UNITED STATES PATENT AND TRADEMARK OFFICE

APPLICATION NO.	FILING DATE	FIRST NAMED INVENTOR	ATTORNEY DOCKET NO.	CONFIRMATION NO.
10/779,835	02/17/2004	Max Arthur Lembke	6579-0082-1	9134
7590 03/06/2006			EXAMINER	
RICHARD R. MICHAUD THE MICHAUD-DUFFY GROUP, LLP 306 INDUSTRIAL PARK ROAD, SUITE 206 MIDDLETOWN, CT 06457			MICHALSKI, SEAN M	
			ART UNIT	PAPER NUMBER
			3725

Office Action Summary

DETAILED ACTION

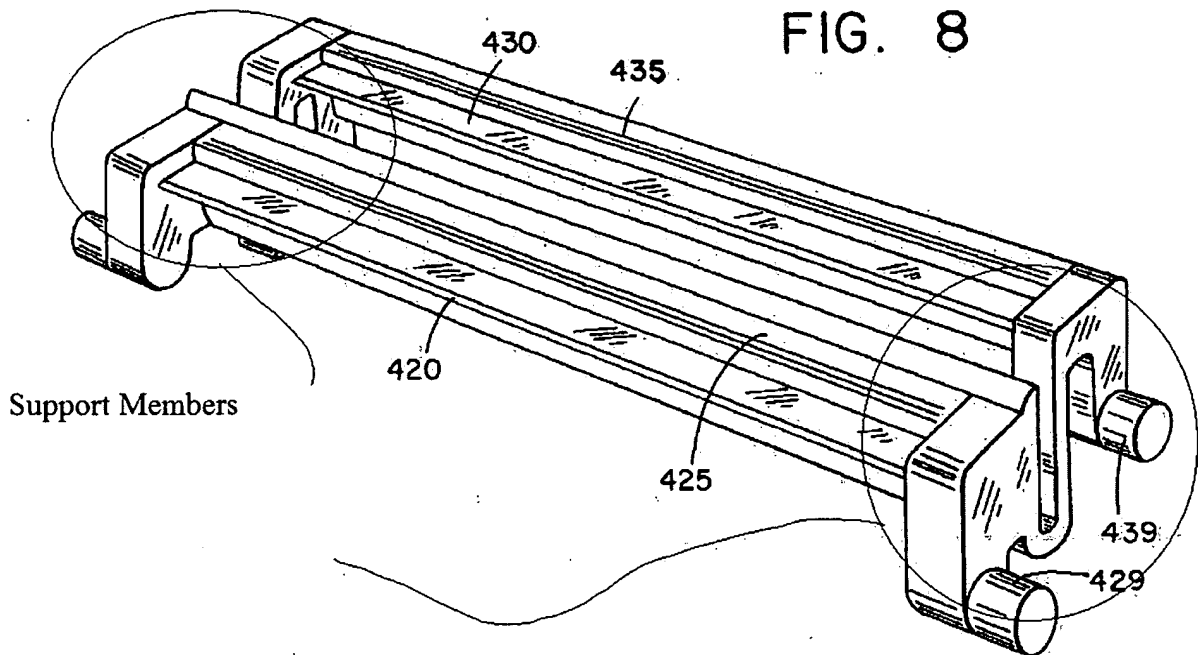
3. Claims 1-5 8, 9 and 11 are rejected under 35 U.S.C. 102(b) as being anticipated by Burout et al. (USPN 5,546,660).
4. Regarding claim 1, Burout et al. discloses a multiple blade razor cartridge comprising a plurality of support members (see figure below)

each having a plurality of blade seats (41 figure 2 or 435 figure 7) forming a row (there are seats on the left and right of the support member; this is a 2 point row), each row separated from the next successive row of seats by a flexible hinge (the link 427 figure 7 is a flexible hinge). Burout et al. further discloses at least one retaining member (425 figure 8) connecting said support members such that said support members are spaced apart and approximately parallel to each other. Burout et al. further discloses a plurality of razor blades (420, 430 figure 8) each fixed to a row of blade seats.

that said rows of blade seats and said blades affixed to said blade seats terminate at said end support members (the blades 420 and retaining member 425, 435 all terminate at the end support members as seen in the figure above).

Fig.1

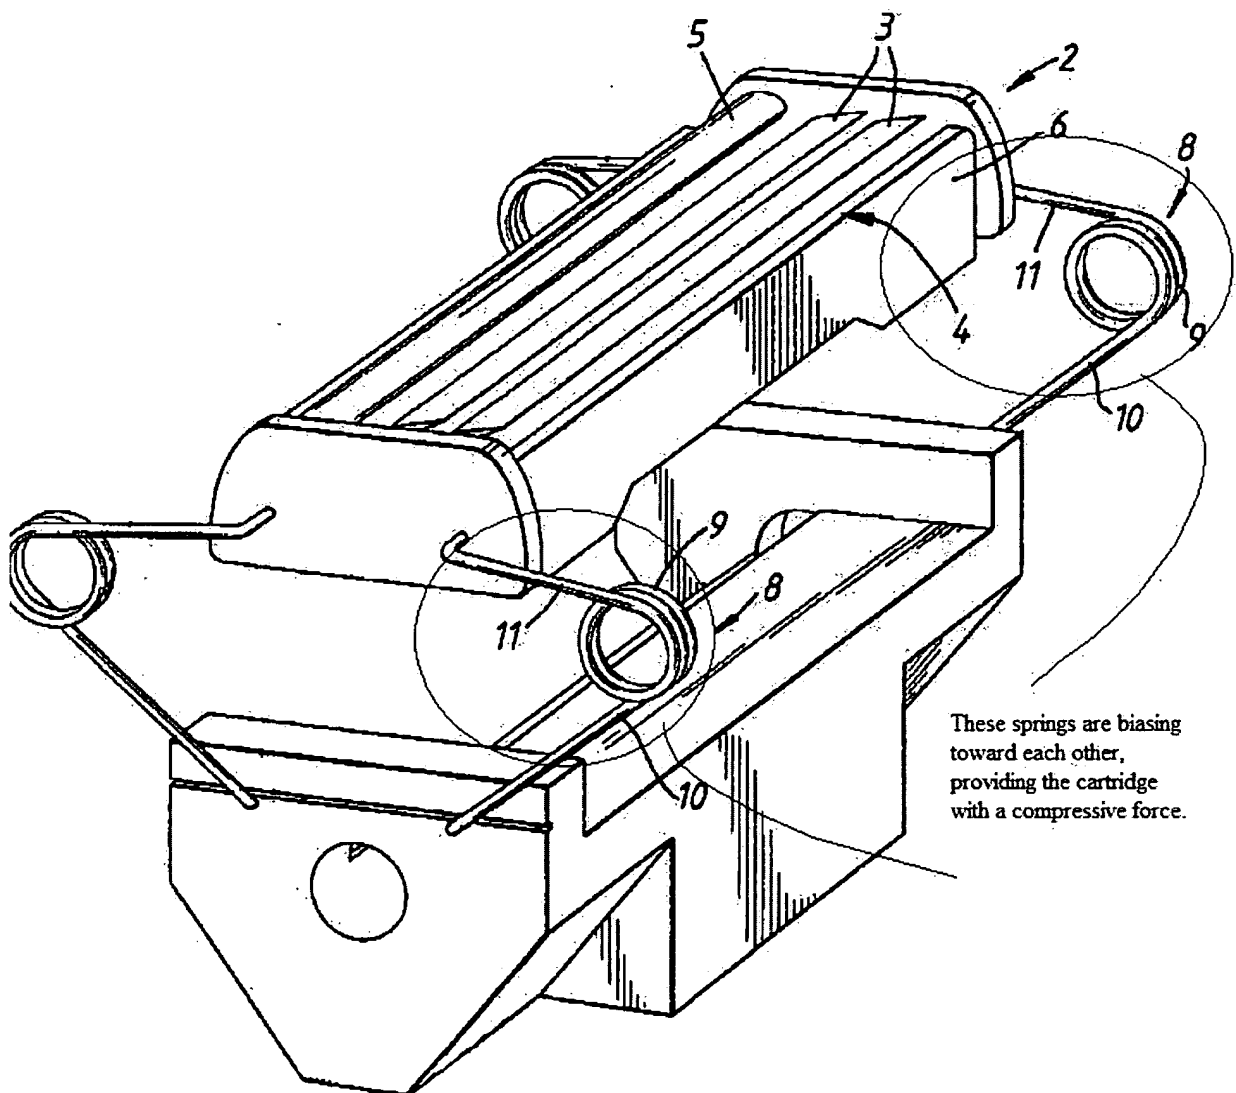
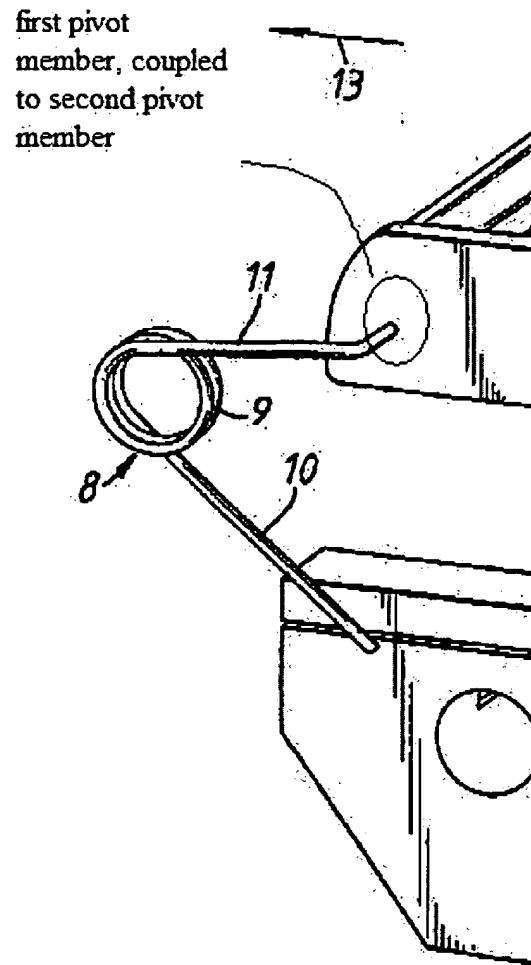
Christman further discloses that said second ends are biased toward one another applying a compressive force to said razor cartridge retained therebetween (column 3, lines 4-6, also see figure below).

Regarding claim 27, Burout et al. in view of Christman et al as discussed above meets all the limitations of the claim. Christman teaches both fore and aft second pivot members (numbers 8, 9, 11 figure 1 form the pivot members) being attached to a handle (1 figure 1), via arm members (10 figure 1). It also teaches first pivot members (the female portion where second pivot members connect to the cartridge, seen in the figure below) being attached to said support members.
